From: Priscilla Burton
To: Mark Reynolds
CC: Helfrich, Joe; Nance, Angela
Date: 5/14/2008 5:10 PM
Subject: Hiawatha Technical Inspection Report
Attachments: insp rpt 1621 map_20080507155127.pdf; Insp Rpt 1621_20080512131002.pdf

Inspection Report

RE: Soil Cover Depth Evaluation. Phase I Bond Release Slurry Pond 4 and 5. Co-Op Mining Corporation, Hiawatha Mine, C/007/0011, Task 2895

HIAWATHA PROCESSING PLANT
AND WASTE DISPOSAL SITES
Ex. V-13

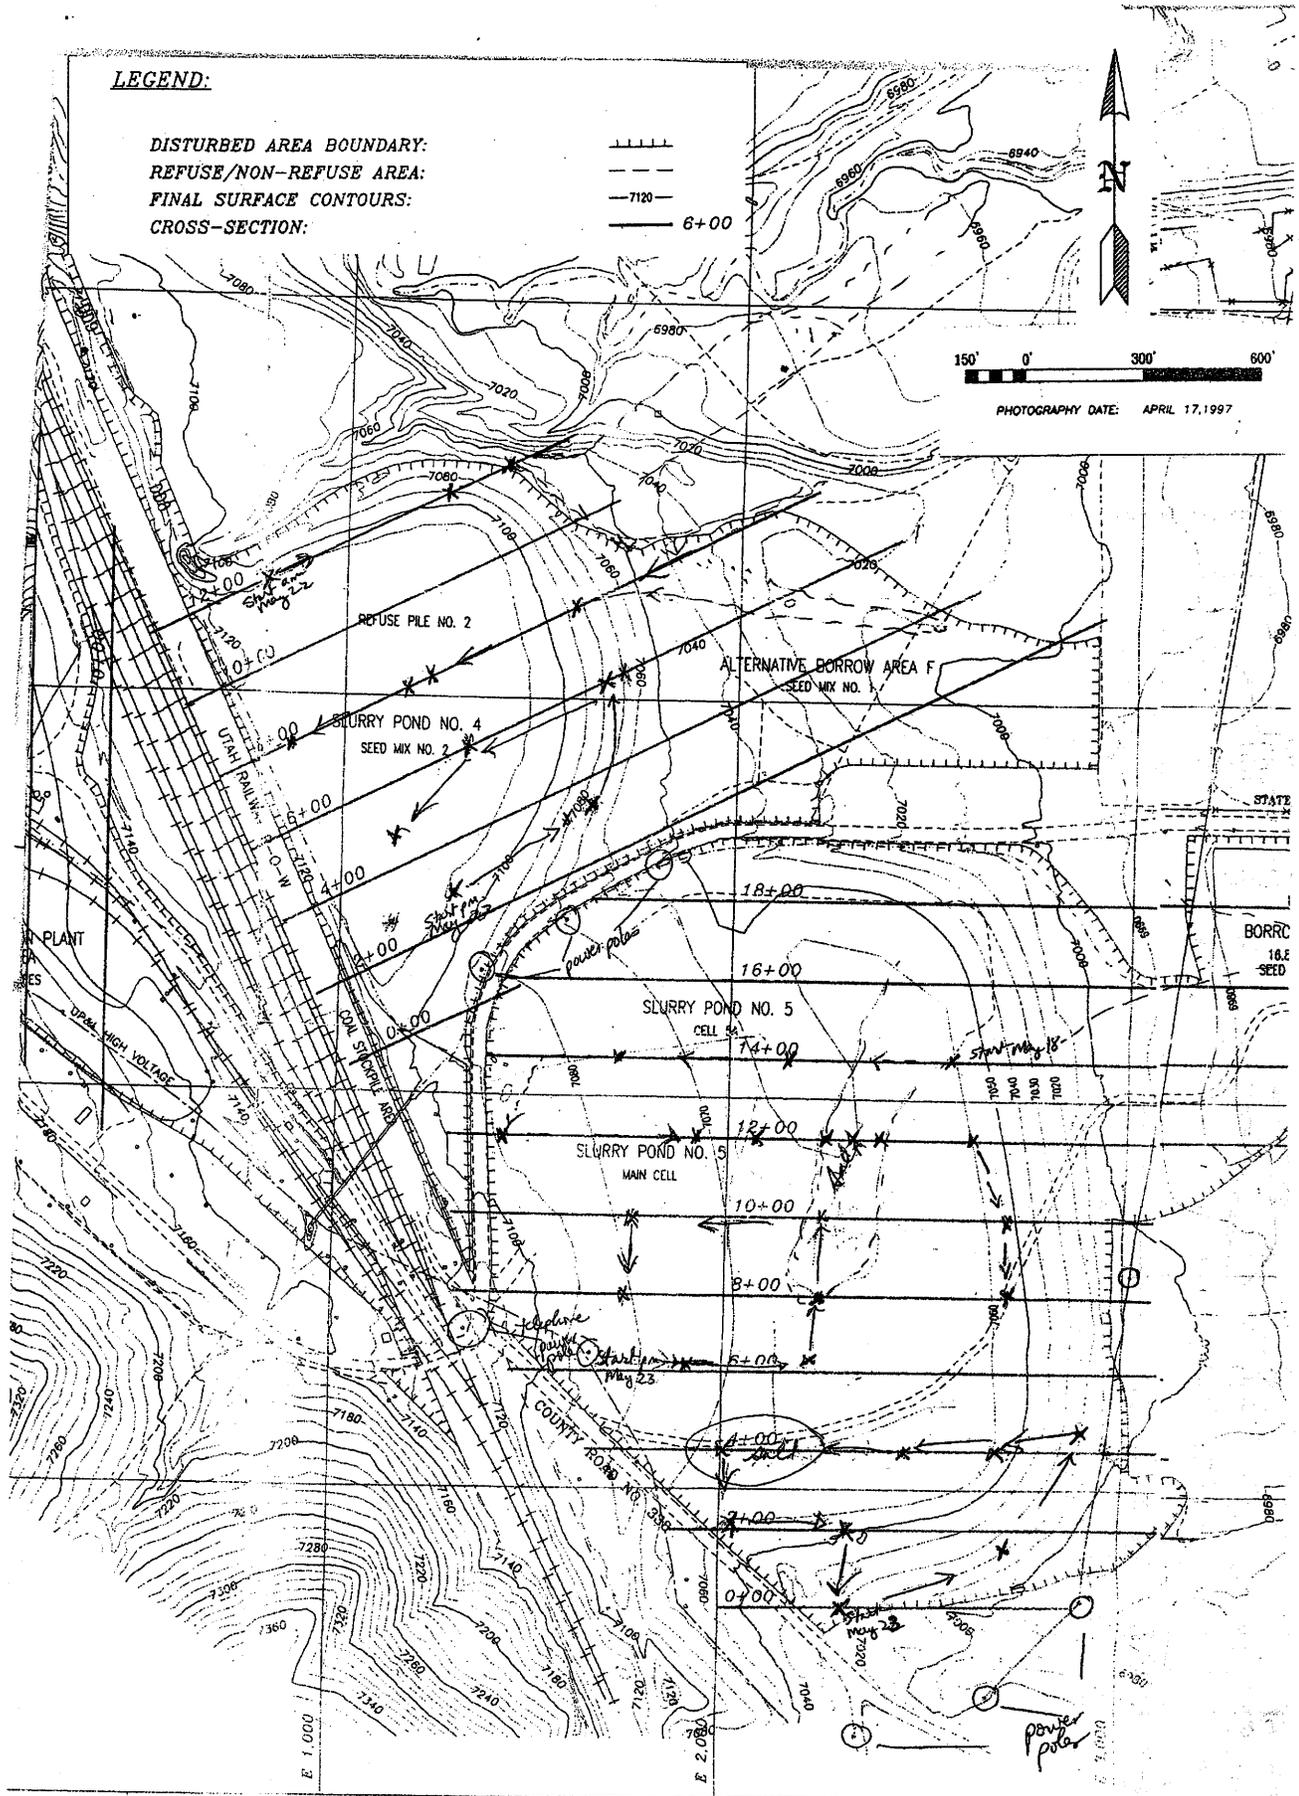
The average cover on Slurry Pond #5 was 15 inches. There are two areas of salt accumulation on the level surface of Slurry pond #5. These areas have less than the average cover and little drainage due to their position. I would like to return to the site to show you these areas and calculate their acreage using a gps unit.

The average on Slurry Pond #4 was 16 inches.

HIAWATHA PROCESSING PLANT
AND WASTE DISPOSAL SITES
Ex. V-13

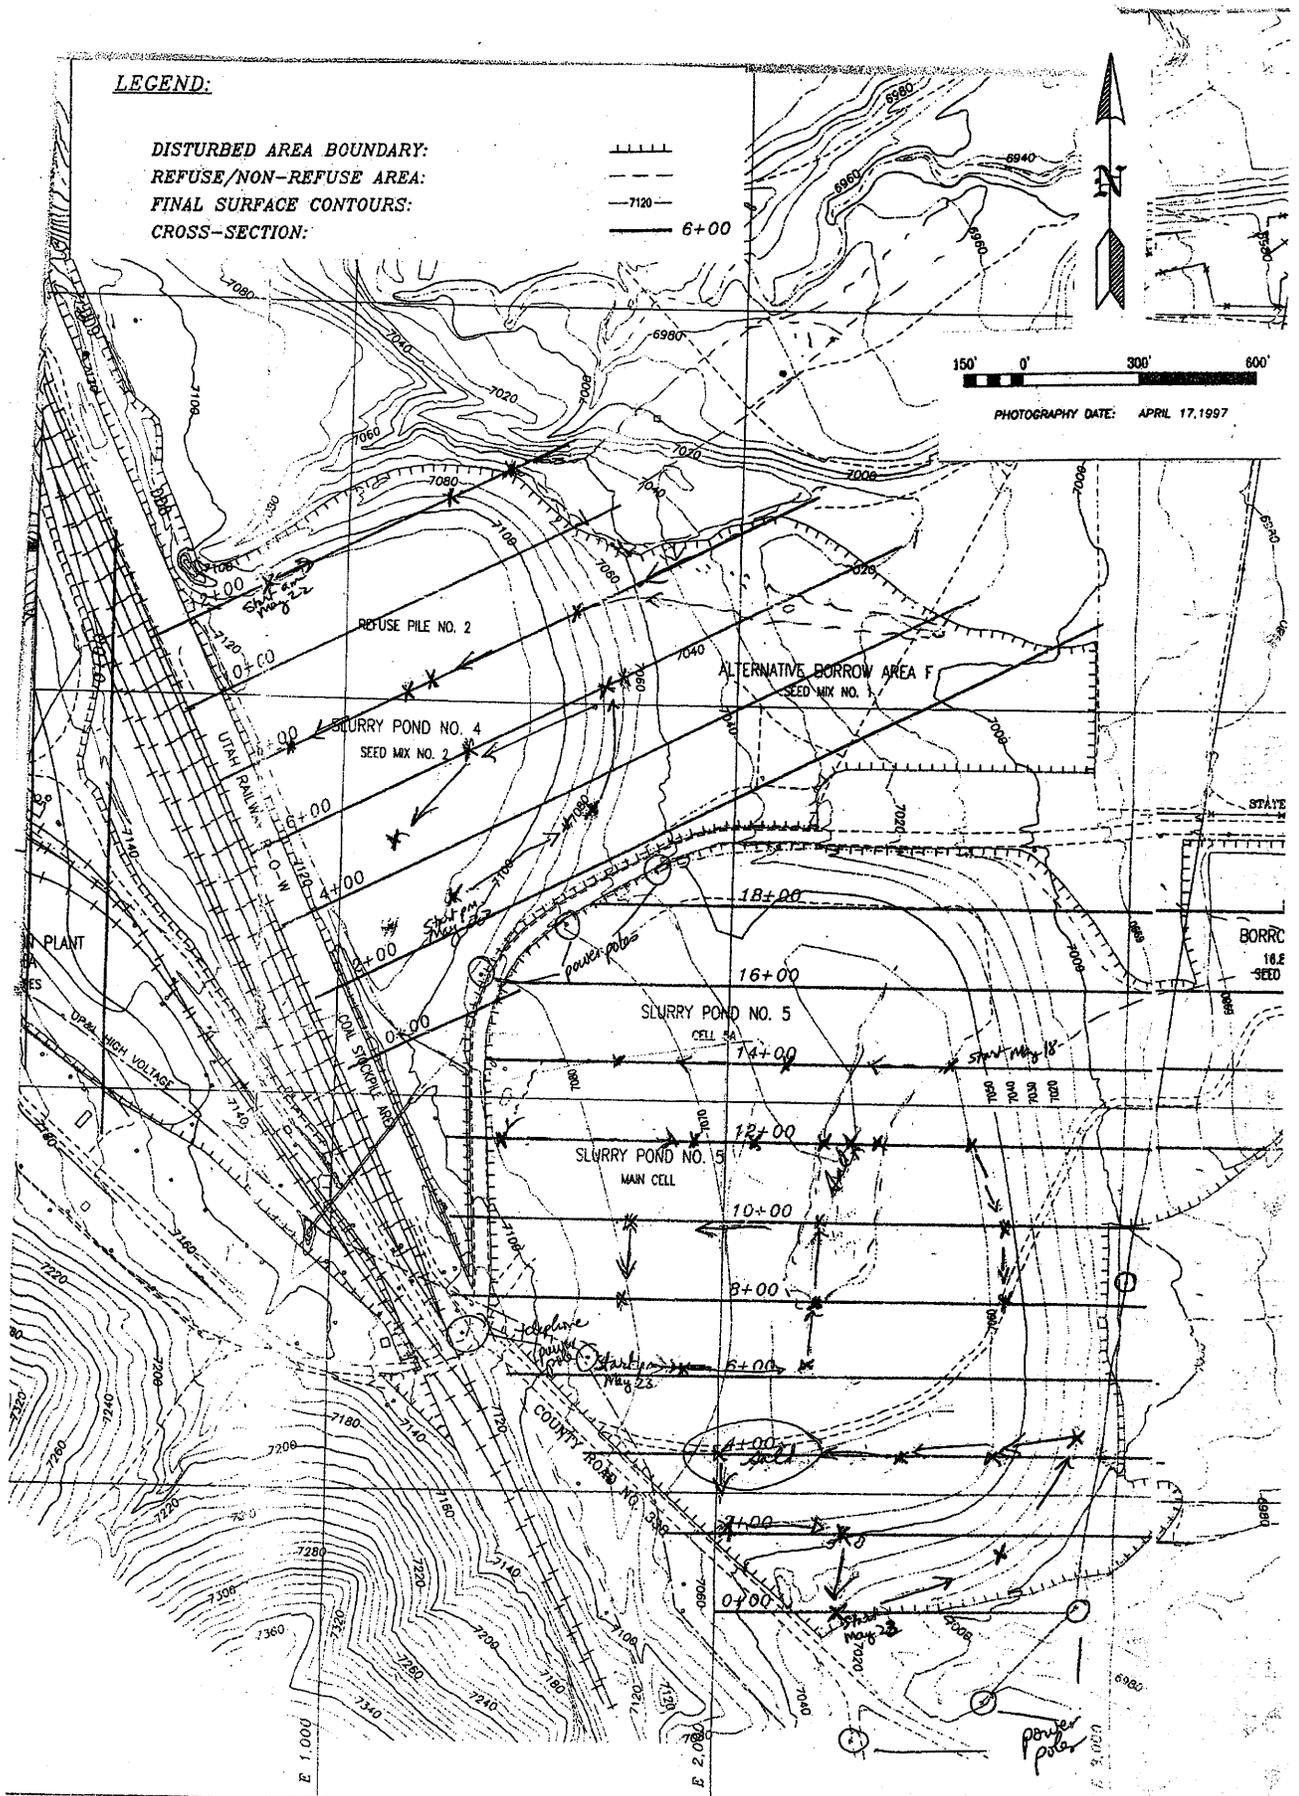
Inspection Report #1621 summarizes the technical site visit. There is an average of 15 inches of cover over Refuse Pile #5 and an average of 16 inches of cover over Slurry Pond #4/Refuse Pile #2. This Attachment provides the details of the cover depth analysis. Auger sites were plotted along the stations shown on Exhibit V-13, Hiawatha Processing Plant and Waste Disposal Sites. A copy of that map is attached. The following tables summarize the notes taken over three days at the site. Photographs are available in the database.

Summary for Refuse Pile #5: 15 inches cover depth was the average for the 23 auger holes dug.

Summary Slurry Pond #4/Refuse Pile #2, 16 inches is the average for the 11 auger holes dug.
